Improved Technical Specifications

Quad Cities Station

Volume 12:
Complete CTS Markup

ComEd

FIGURE 3.4.A-1

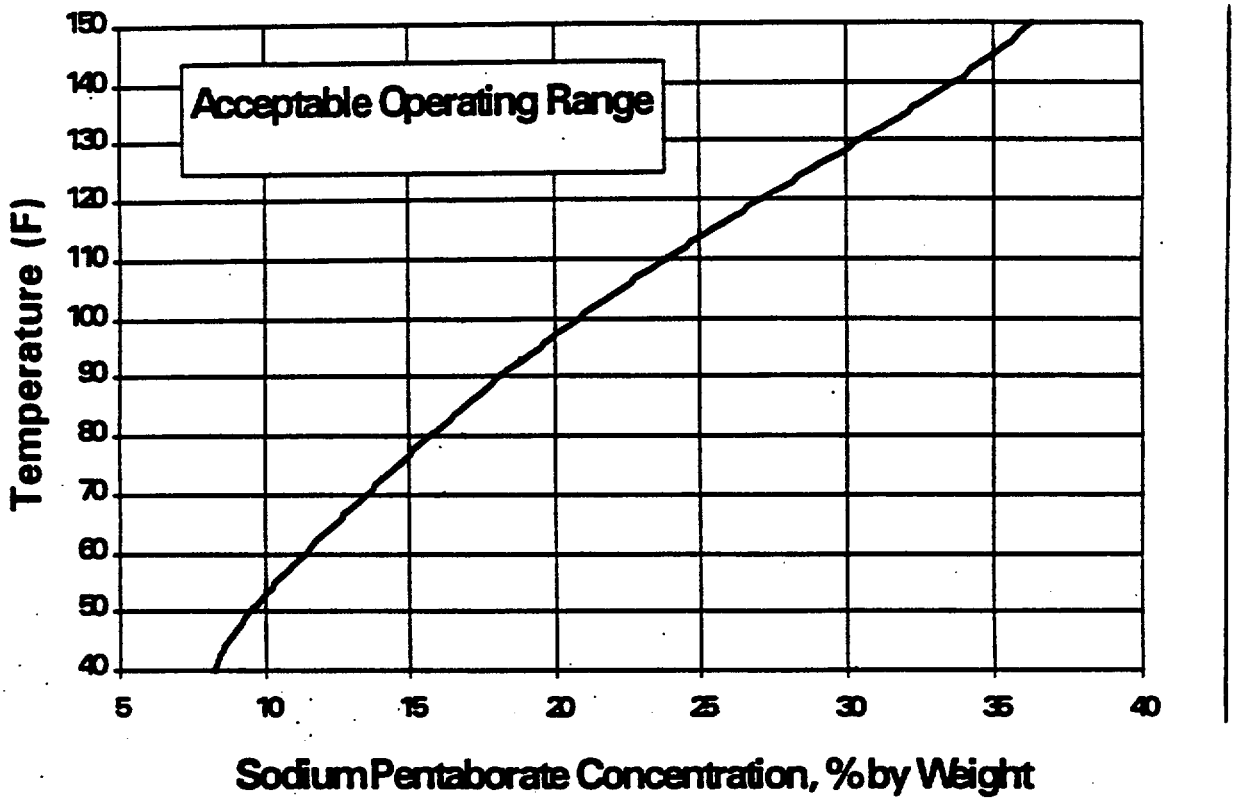
SR 3.1.7.2 a. The temperature of the sodium pentaborate solution is greater than or equal to the limits of Figure 3.4.A-1.

SR 3.1.7.5 a This surveillance shall also be performed anytime water or boron is added to the solution or when the solution temperature drops below the limits specified by Figure 3.4.A-1.

Figure 3.1.7-2

FIGURE 3.4.A-2

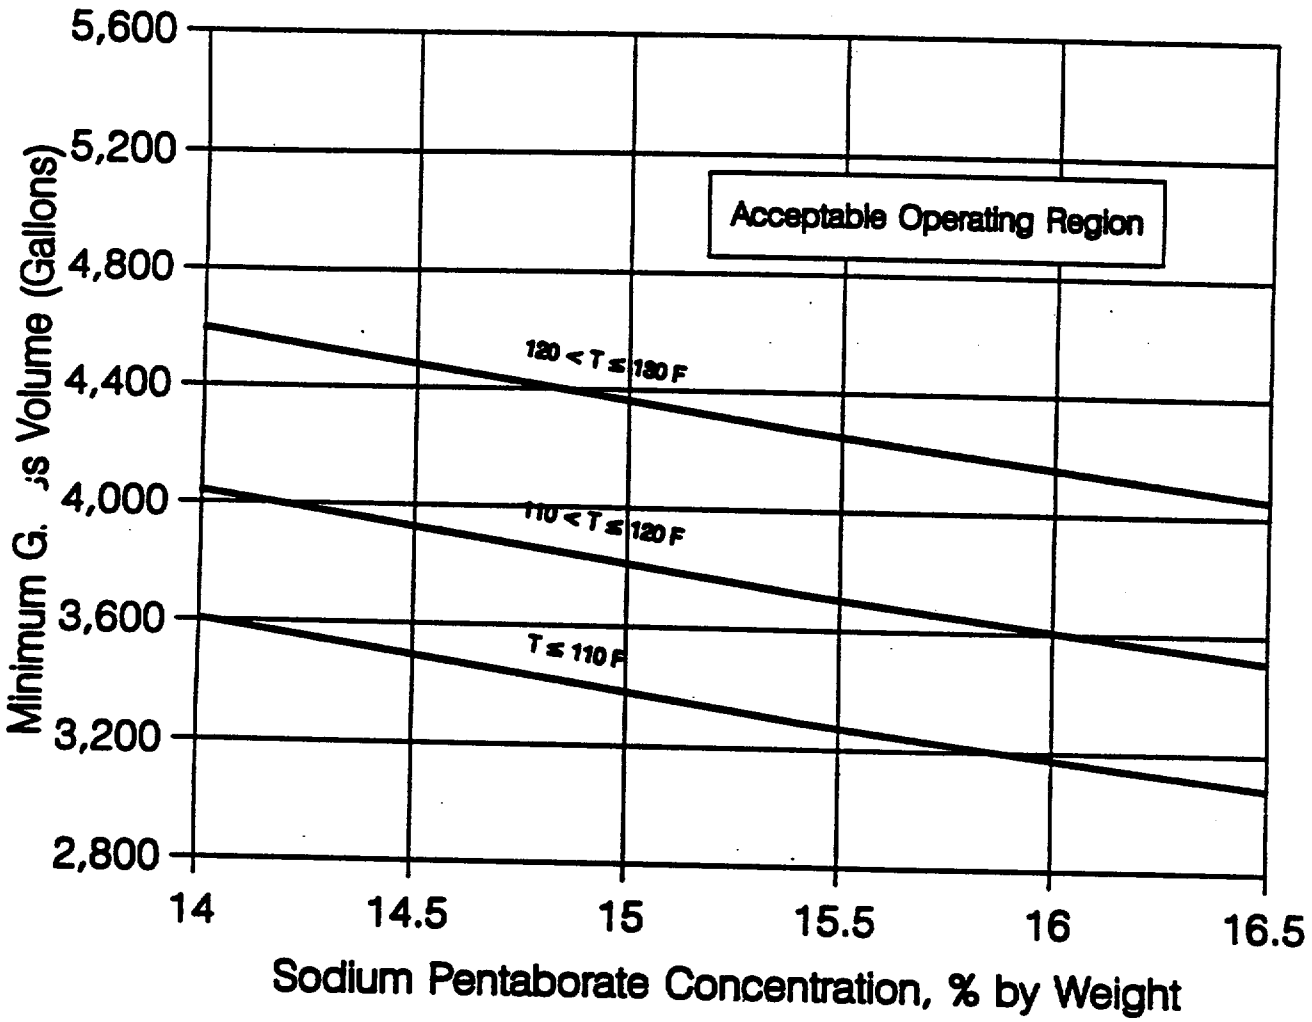
SR 3.1.7.1 b. The volume of the sodium pentaborate solution is greater than or equal to the limits shown in Figure 3.4.A-2.

SR 3.1.7.5 b. Determining[a] ~~by chemical analysis~~ that the available concentration of boron in solution is ~~14% by weight to 16.5% by weight~~ within limits of Figure 3.1.7-1.

Figure 3.1.7-1

FIGURE 3.6.K-1

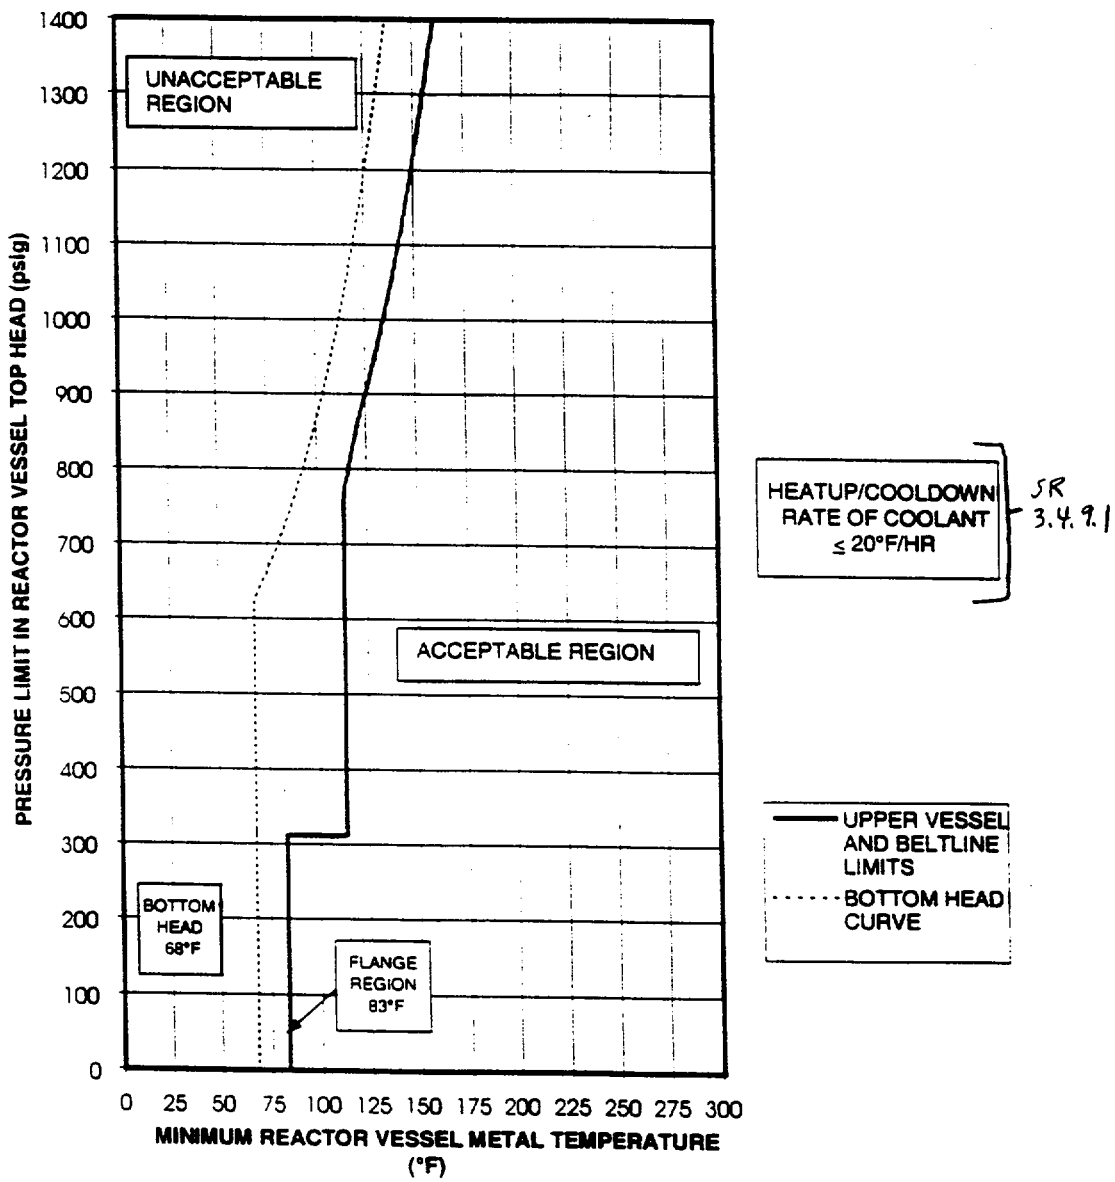
SR 3.4.9.1 a. The reactor vessel metal temperature and pressure shall be maintained within the Acceptable Regions as shown on Figure 3.6.K-1 with the rate of change of the primary system coolant temperature ≤ 20°F per hour, or

FIGURE 3.6.K-2
PRESSURE – TEMPERATURE LIMITS FOR NON-NUCLEAR
HEATUP/COOLDOWN – VALID TO 32 EFPY

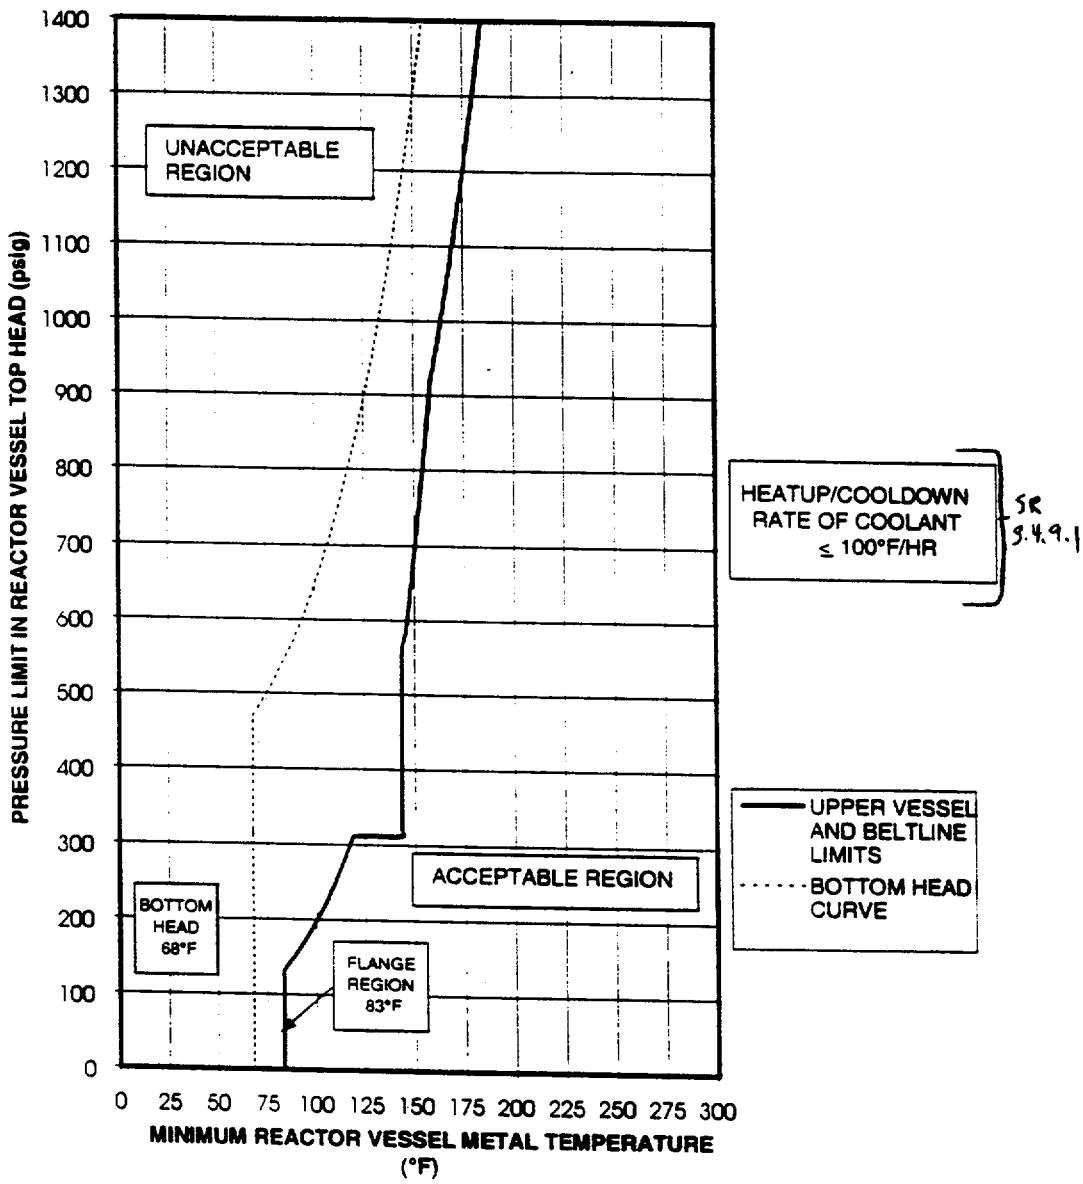
SR 3.4.9.1 b. The rate of change of the primary system coolant temperature shall be ≤100°F per hour when reactor vessel metal temperature and pressure is maintained within the Acceptable Regions as shown on Figure 3.6.K-2.

SR 3.4.9.1 a. The reactor vessel metal temperature and pressure shall be maintained within the Acceptable Regions as shown on Figure 3.6.K-2, and

FIGURE 3.6.K-3
PRESSURE – TEMPERATURE LIMITS FOR CRITICAL CORE OPERATIONS – VALID TO 32 EFPY

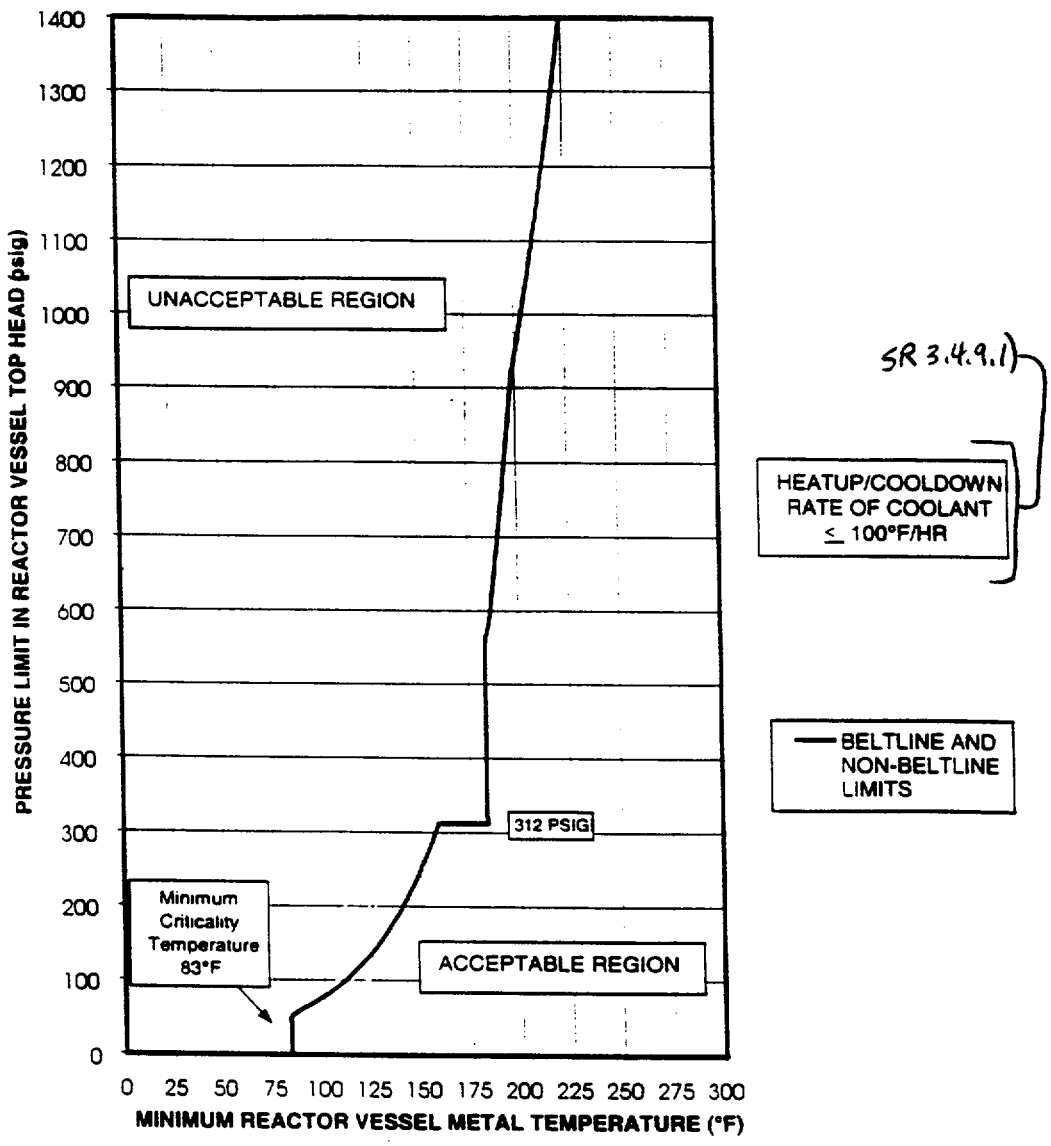
SR 3.4.9.2 b. The reactor vessel metal temperature and pressure to be within the Acceptable Region on Figure 3.6.K-3.

SR 3.4.9.2 — a. The reactor vessel metal temperature and pressure shall be maintained within the Acceptable Region as shown on Figure 3.6.K-3, and
